# HISTORIC AND DESIGN REVIEW COMMISSION

January 17, 2018

**HDRC CASE NO:** 2018-025  
**ADDRESS:** 2125 W MISTLETOE  
**LEGAL DESCRIPTION:** NCB 6829 BLK LOT E 65 FT OF 37 & W 20 FT OF 38  
**ZONING:** R-6 H  
**CITY COUNCIL DIST.:** 7  
**DISTRICT:** Monticello Park Historic District  
**APPLICANT:** Dina Saad  
**OWNER:** Charles Harvey and Dina Saad  
**TYPE OF WORK:** Window replacement  
**APPLICATION RECEIVED:** January 04, 2018  
**60-DAY REVIEW:** March 05, 2018  
**REQUEST:**

The applicant is requesting a Certificate of Appropriateness for approval to replace a window on a rear addition with wood windows in a modified configuration.

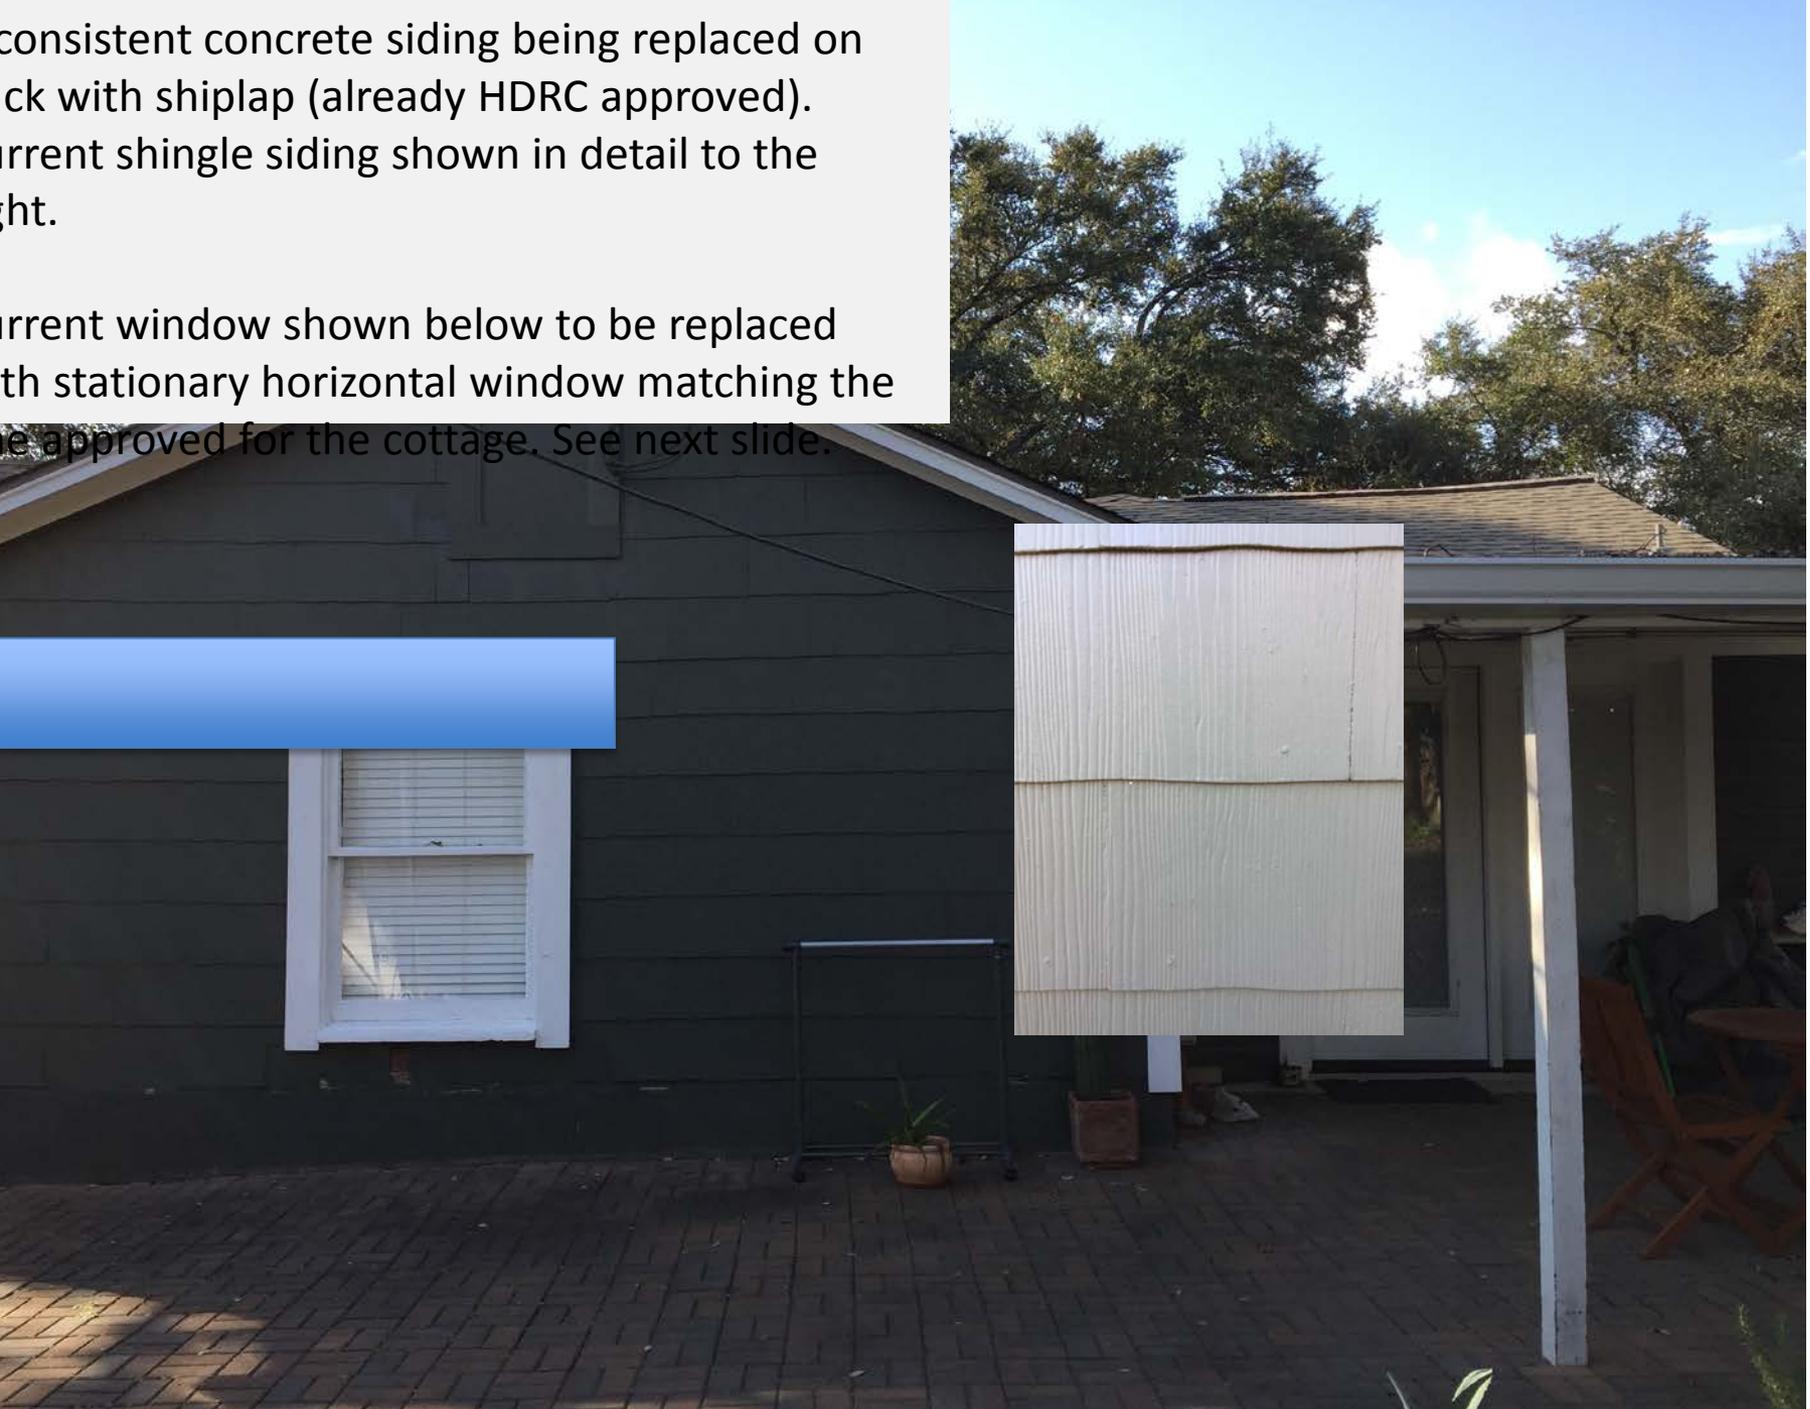
consistent concrete siding being replaced on  
back with shiplap (already HDRC approved).  
Current shingle siding shown in detail to the  
right.

Current window shown below to be replaced  
with stationary horizontal window matching the  
one approved for the cottage. See next slide.

GUEST COTTAGE = RIGHT-HAND/EAST ELEVATION

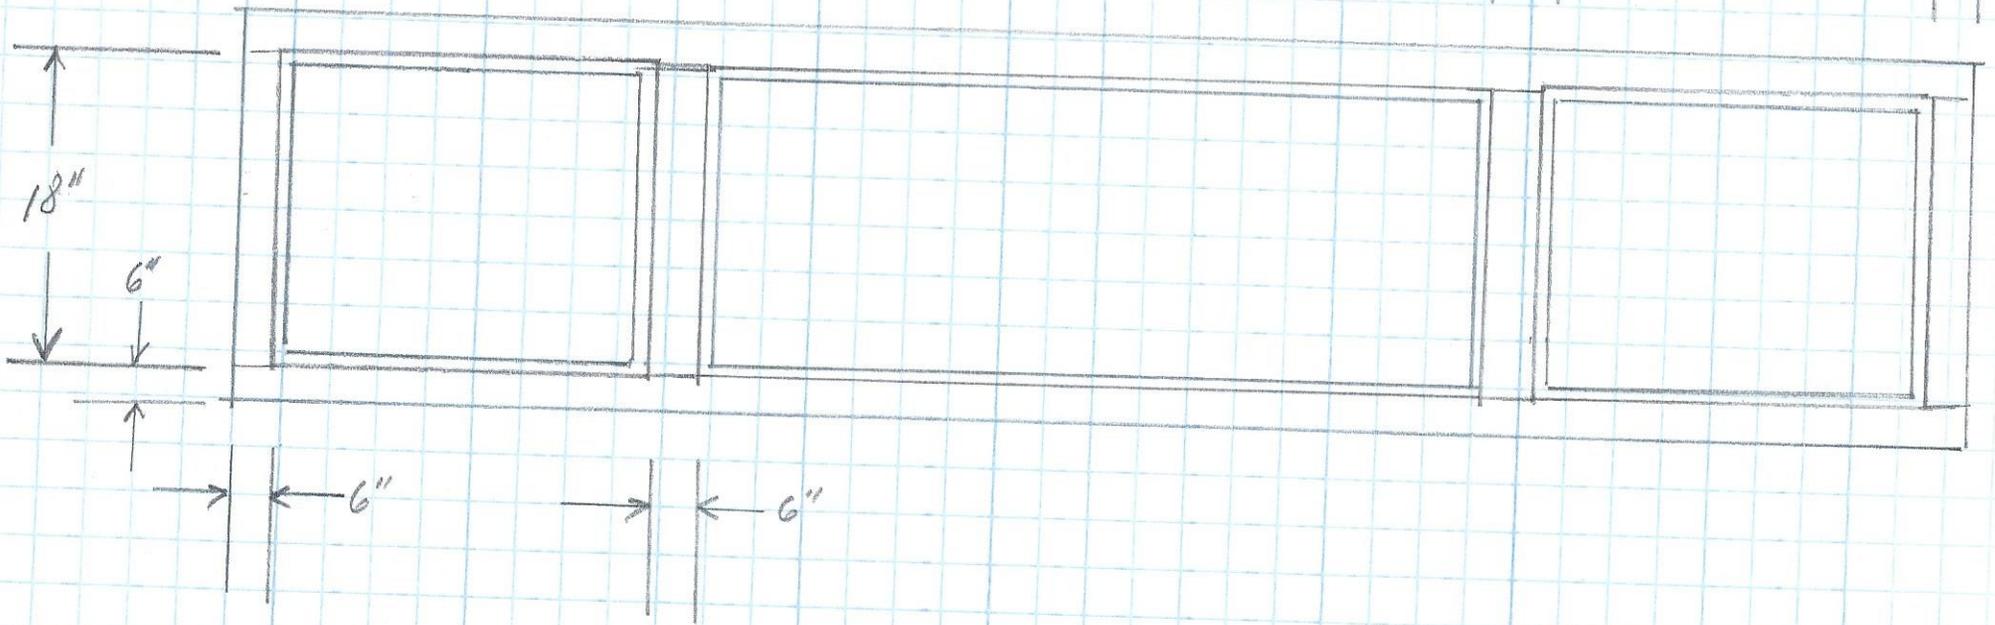
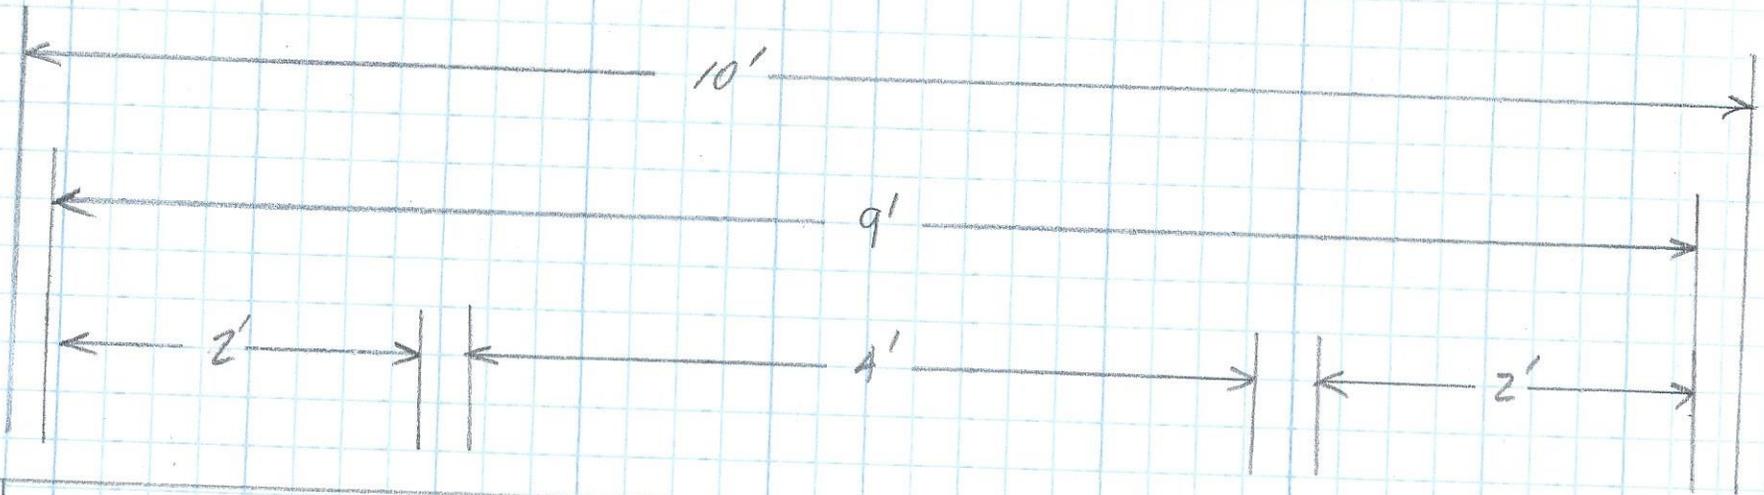
New horizontally oriented window to match the one approved for the cottage, shown below.
